Product Change Notification

103580 - 00

Change Notification #: 103580 - 00
Change Title: RCPXA26x, RDPXA26x & QLPXA26x, PCN 103580-00, FYI, Product Marking
Date of Publication: September 05, 2003

Key Characteristics of the Change:
Product Marking

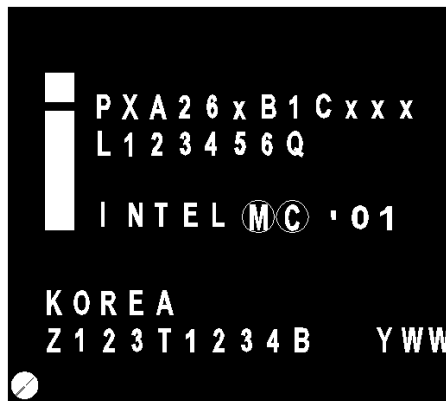
In order to differentiate between lead-free and non lead-free product, the mark on the products covered by this PCN, will be changed as follows:

- Intel's name, before the mask copyright, will be removed.
- On lead-free products, the lead-free designator "E" will be added after the mask copyright date.
- On non lead-free products, the lead-free designator "E" will be missing after the mask copyright date.

See below for examples of how the product mark will change. No other changes will be made to the product.
